PLANNING COMPLIANCE

oppermann associates		ARCHITECTS & INTERIOR DESIGNERS	
Unit D1, The Millhouse, The Steelworks, Foley Street, Dublin 1.		Tel: (01) 8898800 Fax: (01) 8898899 email: architecture@oppermann.ie	
CLIENT:	JACKIE GREENE CONSTRUCTION	DRAWN BY:	MT
PROJECT:	20-773 - RESIDENTIAL DEVELOPMENT AT HAYDEN'S LANE, LUCAN	CHECKED BY:	SOS
DRAWING:	PROPOSED BLOCK 2 SECOND & THIRD FLOOR PLANS	SCALE:	1 : 100 @ A1
DRAWING NO.:	20773-OPP-02-ZZ-DR-A-9007-PP-P02	PLOT DATE:	30.06.2022
REVISION	DATE	REVISED BY	DESCRIPTION
P02	2024.04.18	AD	Compliance with Planning Conditions
P01	2021.12.17	SOS	Issued for Planning Permission

BLOCK 2 SECOND FLOOR PLAN
1 : 100

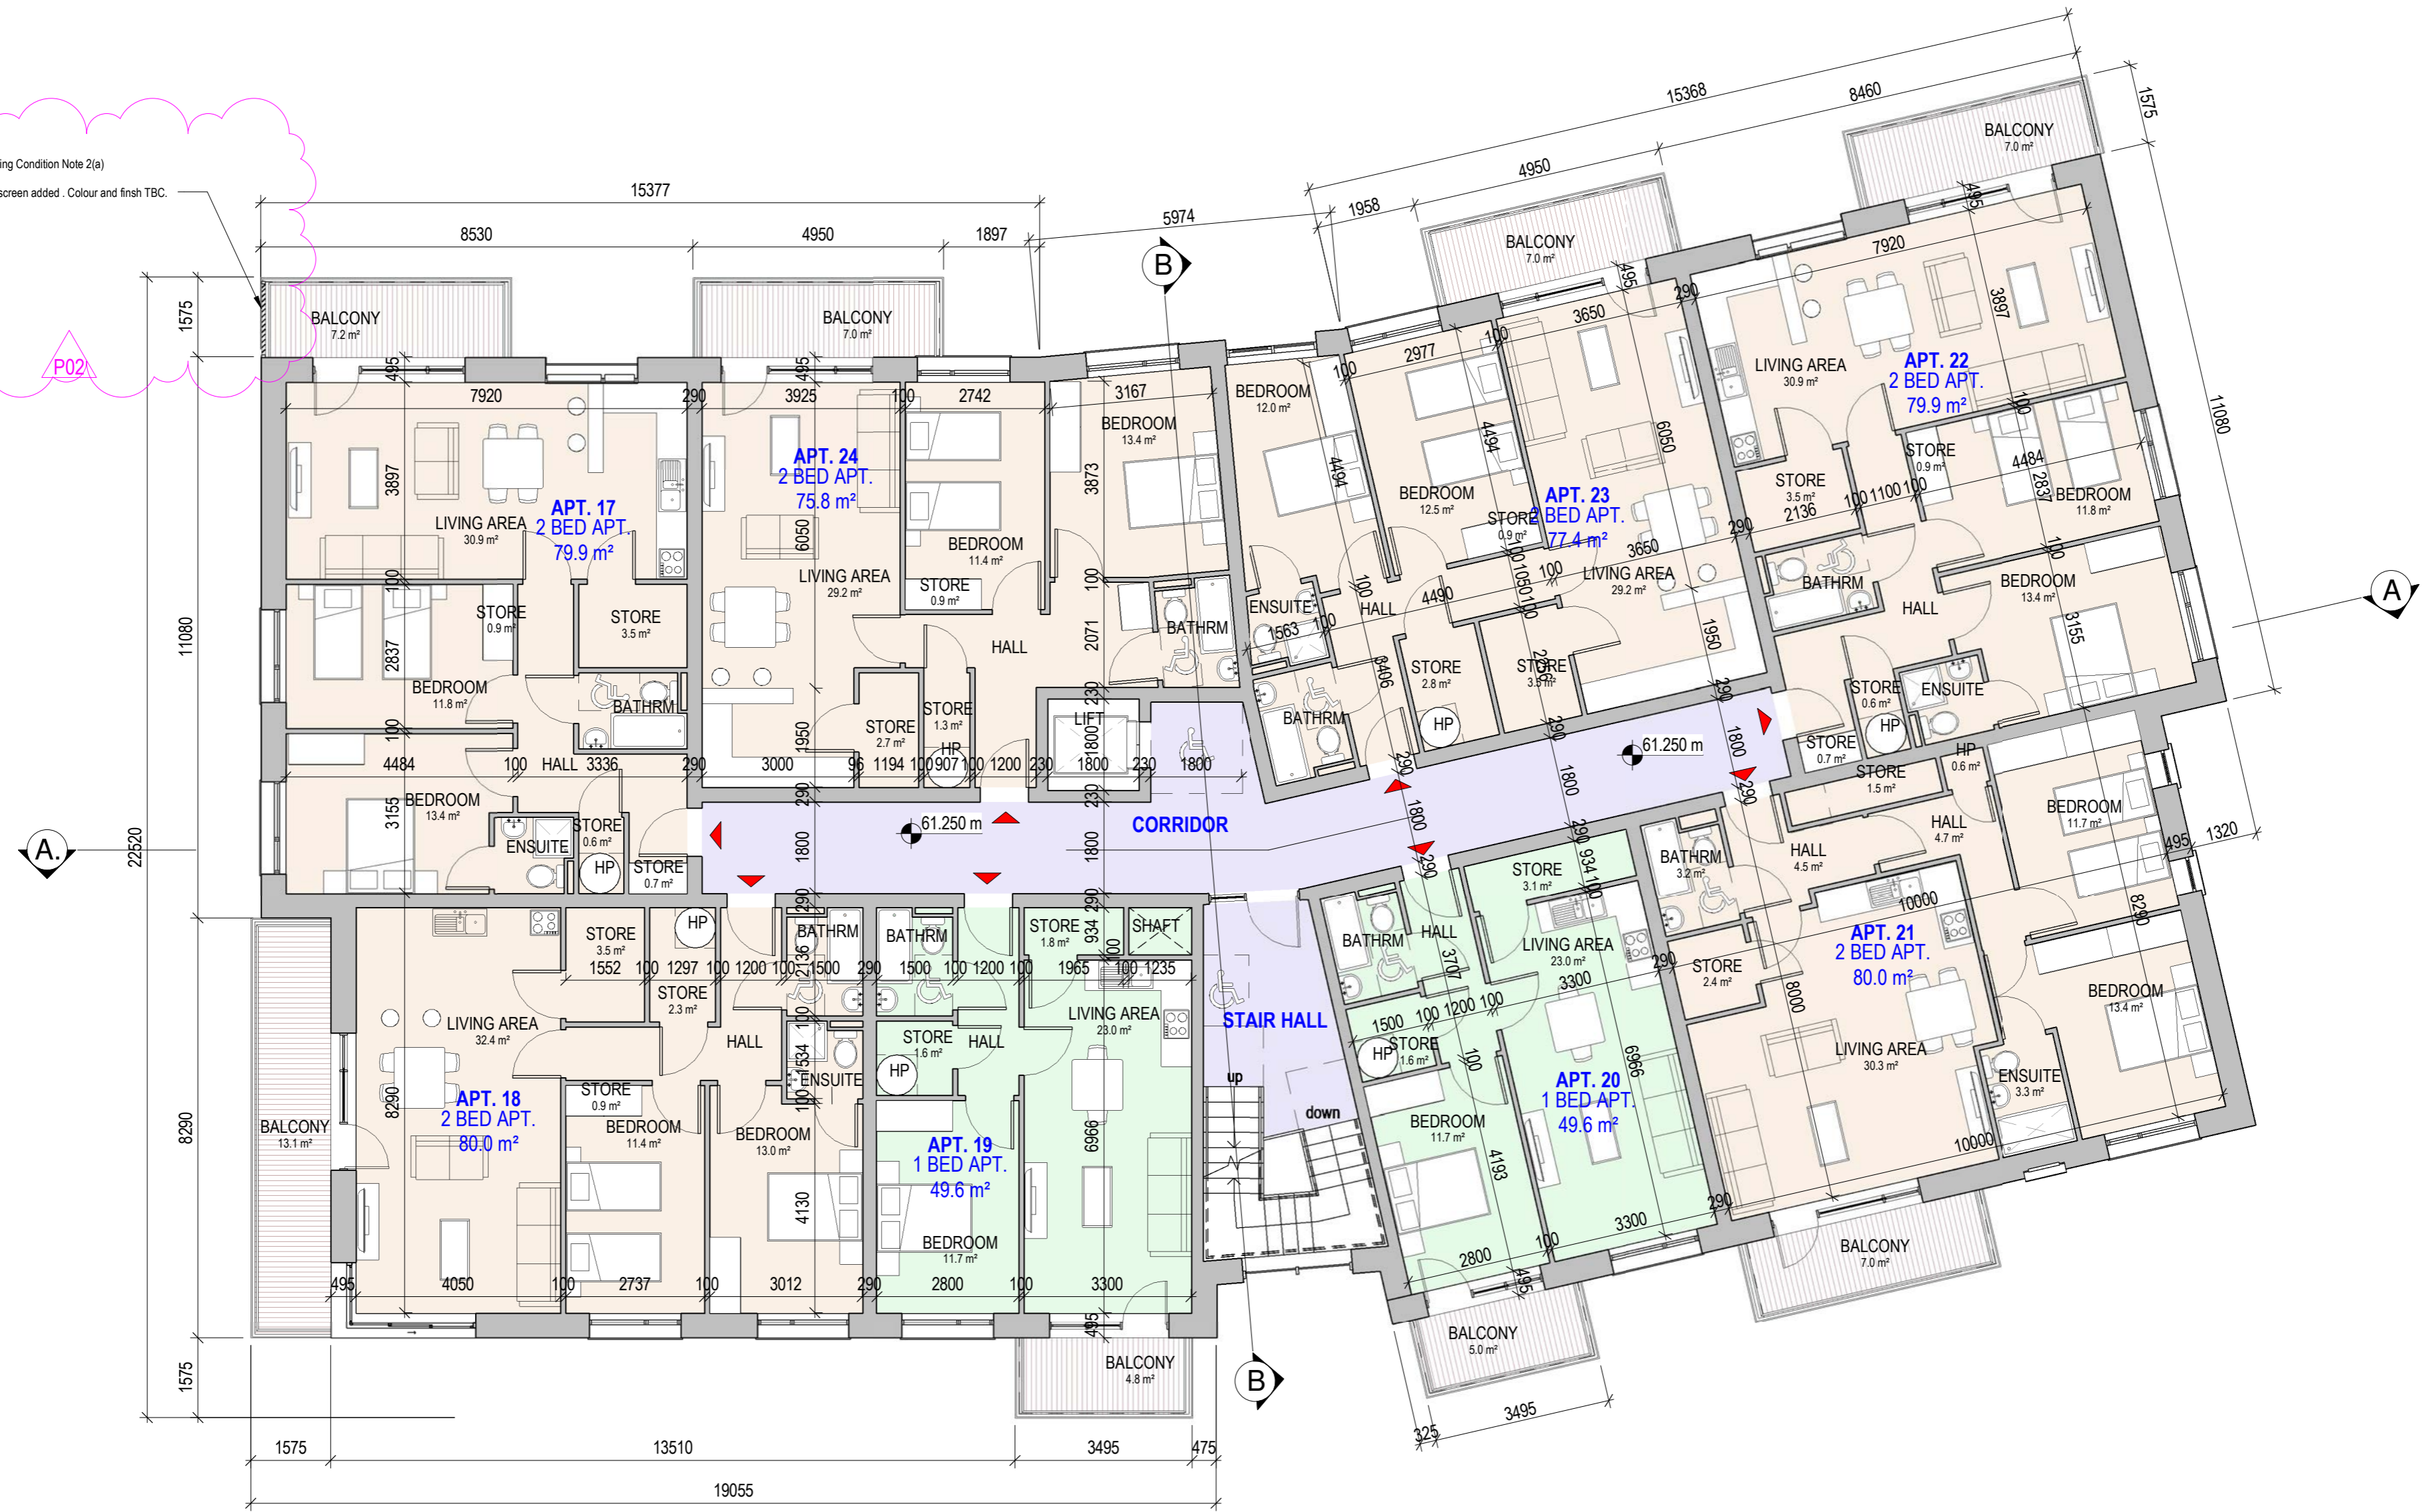
Compliance with Planning Condition Note 2(a)
(ABP-314272-22)
Loured metal privacy screen added. Colour and finish TBC.

BLOCK 2 THIRD FLOOR PLAN
1 : 100

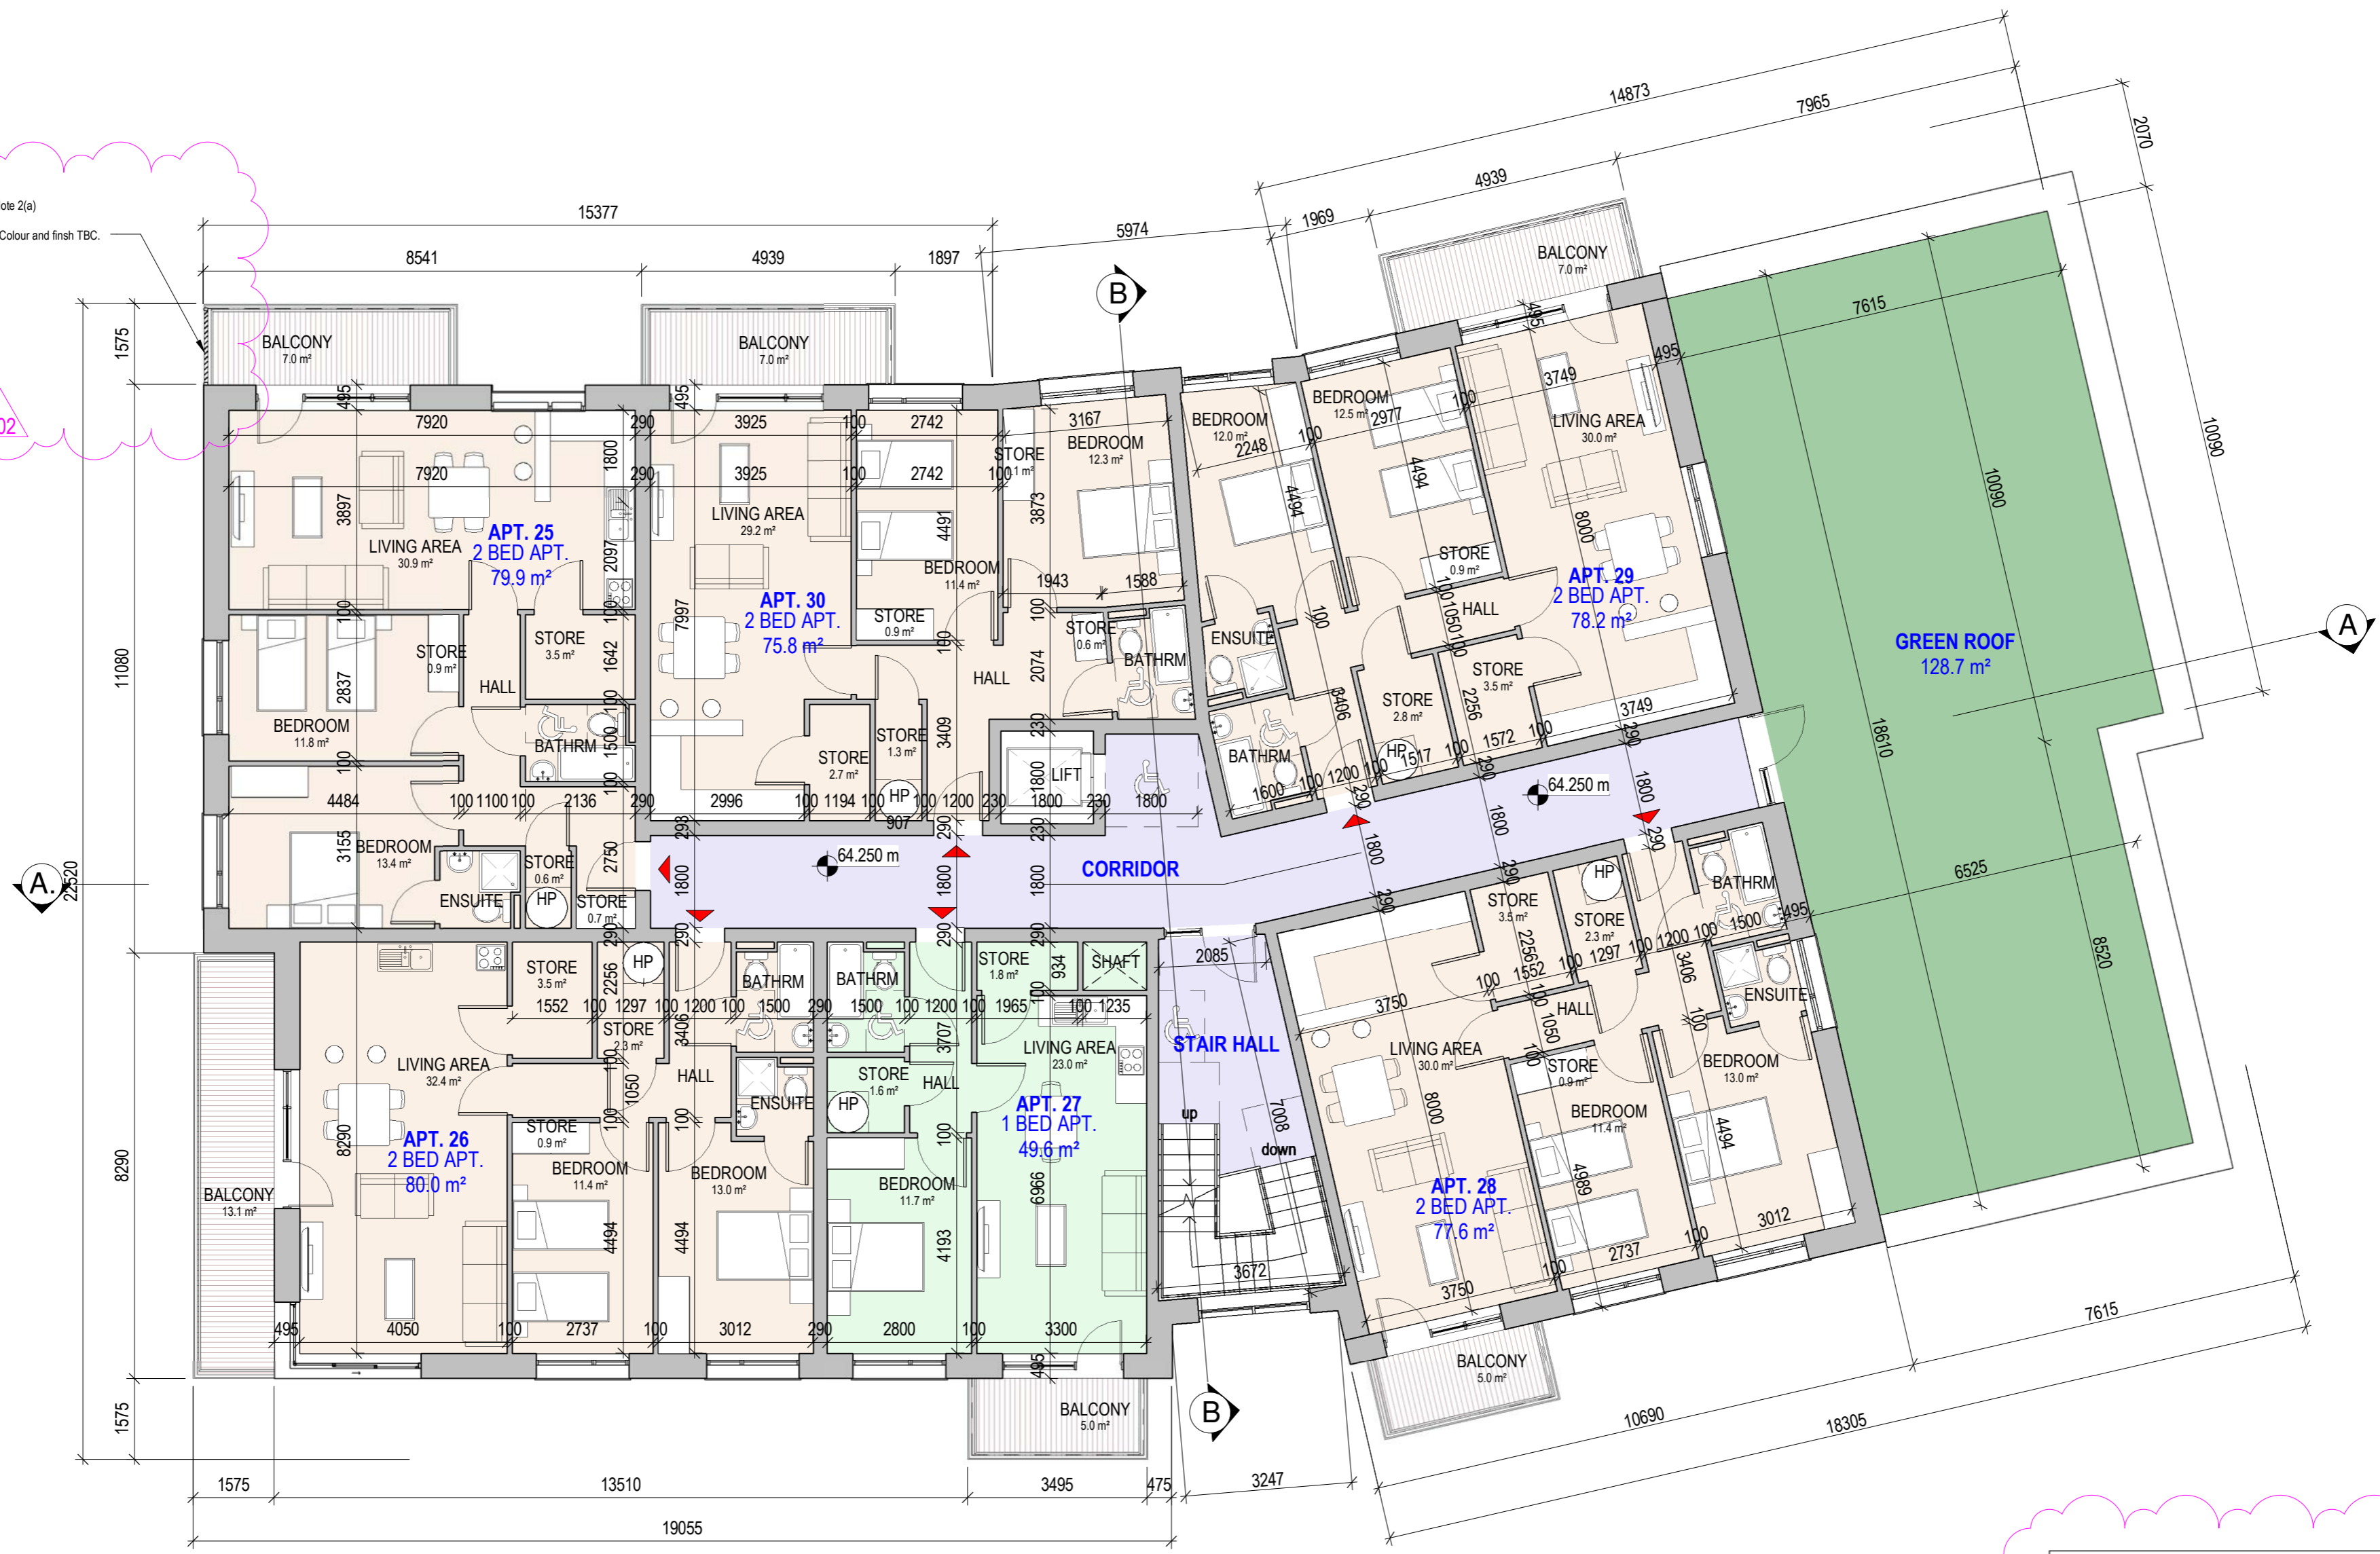
Compliance with Planning Condition Note 2(a)
(ABP-314272-22)
Loured metal privacy screen added. Colour and finish TBC.
